Technical Requirements RA20032

Application under the *Agricultural Operation Practices Act* for a confined feeding operation, manure collection area, and/or manure storage facility(ies)

NRCB USE ONLY	Application number	Legal land description
<input checked="" type="checkbox"/> Approval <input type="checkbox"/> Registration <input type="checkbox"/> Authorization <input type="checkbox"/> Amendment	RA20032	NW 15-33-21 W4M

Earthen Manure Storage Volume Calculator

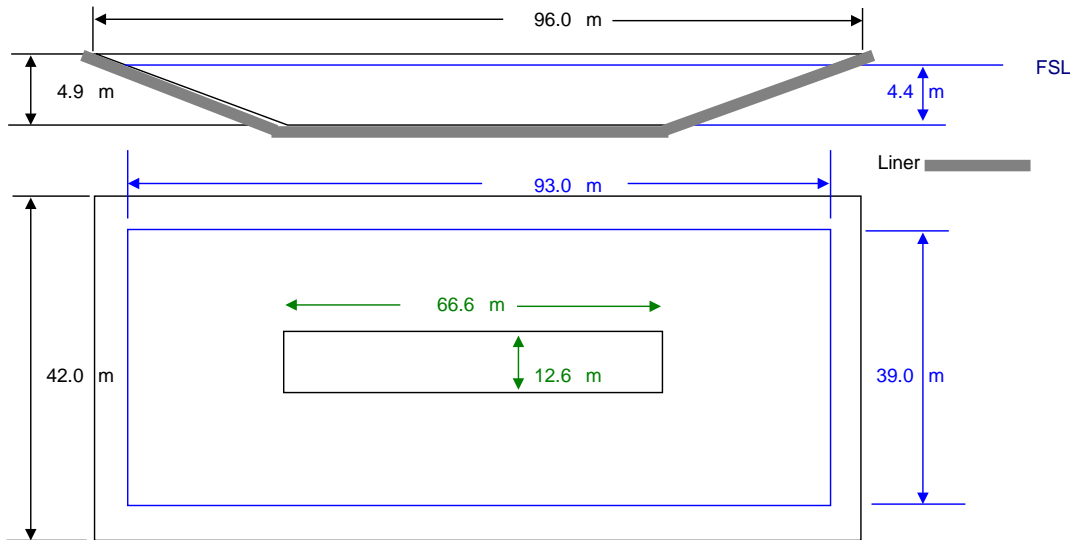
AO Note: The minimum requirements of 6450 cubic metres is based upon a traditional parlour milking system. These requirements include 30 L/cow/day wash water. The applicant is proposing to use a robotic milking system. These systems typically use considerably less water than parlours. Therefore, the actual nine month storage requirement will be less than the 6450 cubic metres. Nevertheless, the applicant has provided more than sufficient amount of storage capacity.
